# ADDENDUM NO. 1

APRIL 17, 2017

**RE: COLVILLE AIRPORT TRANSMISSION MAIN**

**OWNER: CITY OF COLVILLE**

DUAL PIPE TRENCH DETAIL

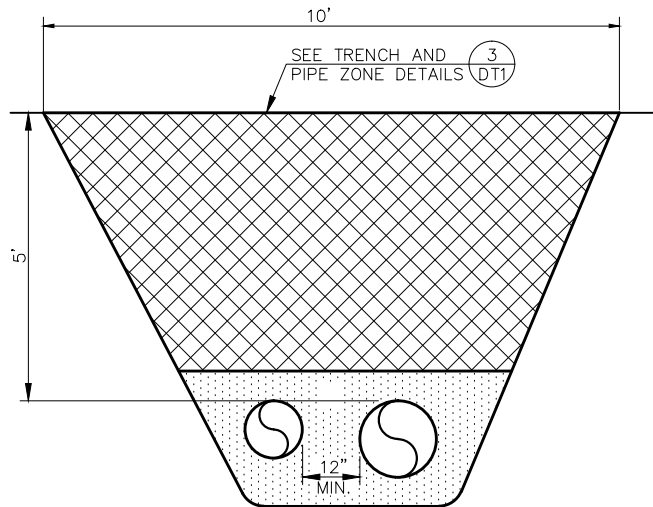
With reference to **Sheet DT1**, replace Detail 5 with attached revised Dual Pipe Trench Detail.
